REGULAR PLANNING COMMISSION AGENDA

PLANNING COMMISSION STAF CONDITIONAL USE PERMIT USE2023 0003 HEARING DATE: JULY 11, 2023

Project Description – The Applicant is requesting a Conditional Use Permit (CUP) for a dock up to 500 feet long and 70 feet wide, and uplands development that includes vehicle parking, tourism logistics, retail, restaurants and a park (**Attachment A1-A5**).

Figure 6: The back-out parking shown on the site plans is conceptual only. CBJ will not permit back-out parking into the right-of-way for commercial uses.

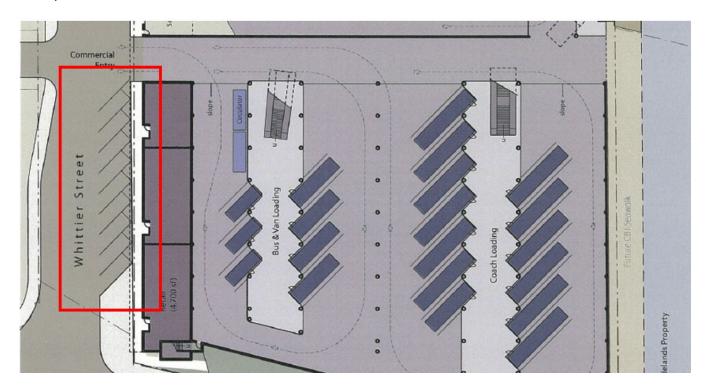
The back-out spaces shown on Whittier Street in the site plans <u>are not included</u> in the parking calculations for the project. The spaces are conceptual. CBJ does not allow commercial uses to have parking that backs into the right-of-way.

Figure 7: Seawalk elements outlined in red are shown for concept only, and are not part of this approval or project.

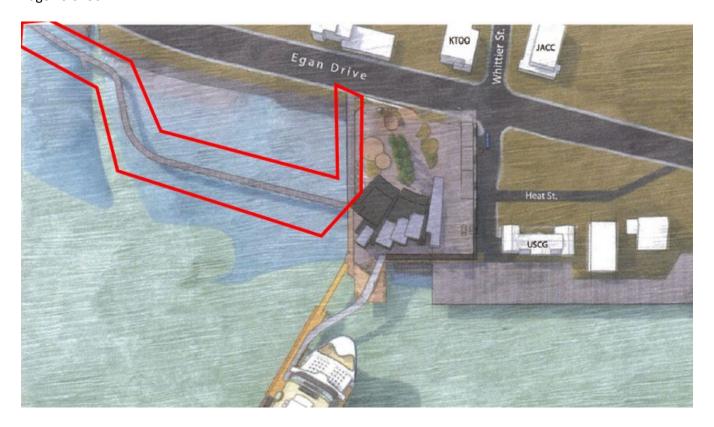
Non-motorized Transportation – The seawalk elements shown over CBJ-held tidelands, outlined in red below, are conceptual. The applicant was asked to conceptually show how the project could connect to a seawalk or bridge to Gold Creek, features that are included in the Long Range Waterfront Plan. CBJ does not have plans for their tidelands lot (shown in **Figure 3**, above) at this time.

Figure 10: In the absence of a CBJ seawalk connection, pedestrians can access the Egan Drive sidewalk via the park. The park will be designed to provide sidewalk access at the east and west ends of the park, with an earthen berm dissuading pedestrian access along the length of the lot line.

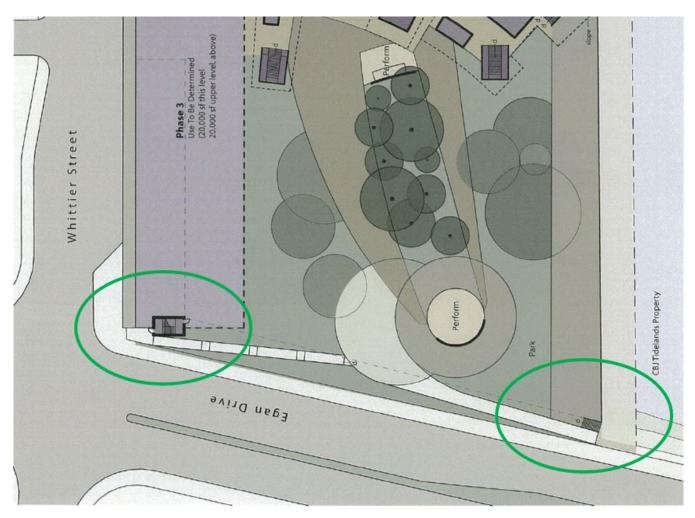
discourage direct access along the rest of the north side. CBJ Parks and Recreation requests a condition that the park be maintained for year-round activities by the Applicant (**Attachment E, page 11**). In the past, other large developments have included amenities, (e.g. playgrounds, parks), but vague direction has led to confusion on maintenance responsibility.

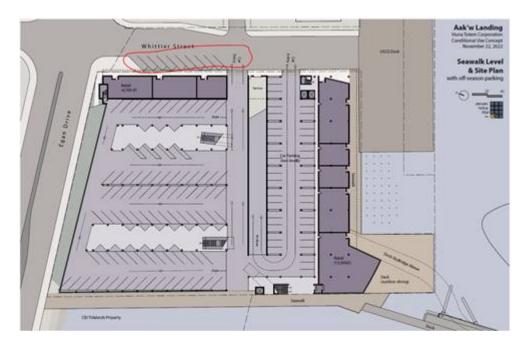
I understand you are referencing the parking proposed along Whittier Street in the draft plans for the Aak'w Landing development (see red circle in the graphic below).

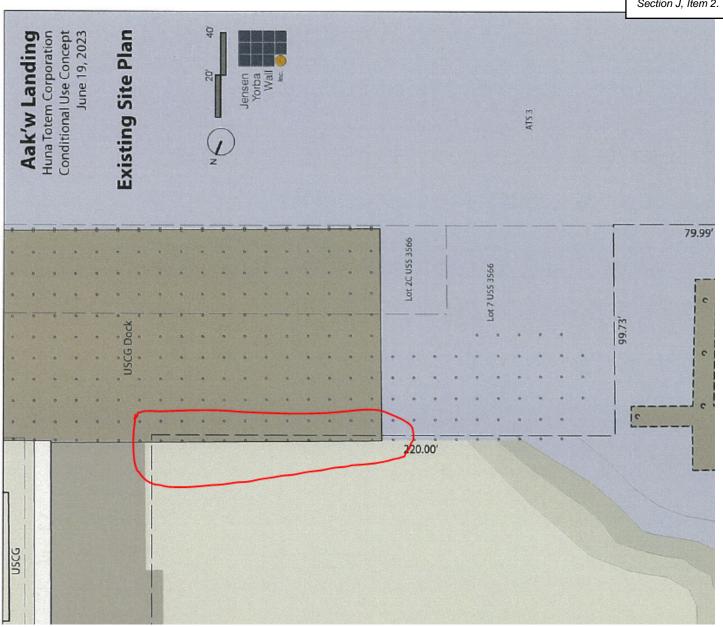
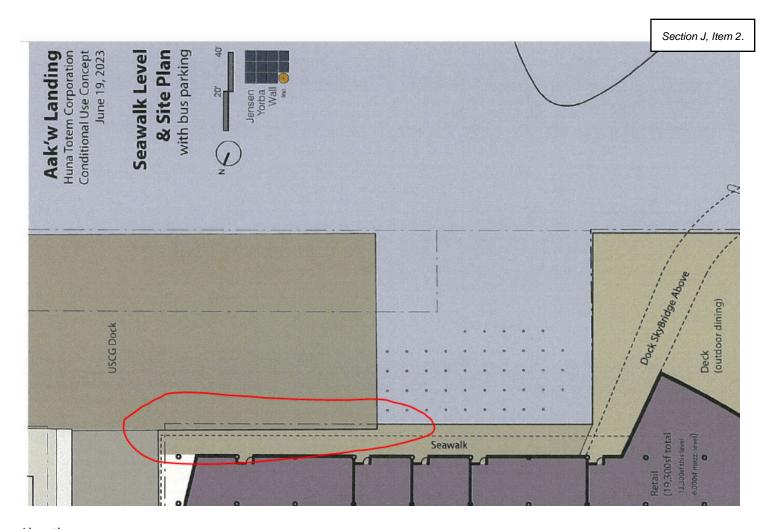
I think they mean the area below:

When I look at subsequent drawings, based on color, it looks like development of the seawalk does not extend onto Coast Guard property. Is that correct? I remember Mickey talking about this at one of our meetings, so I think you are aware and designing appropriately, but wanted to double check.
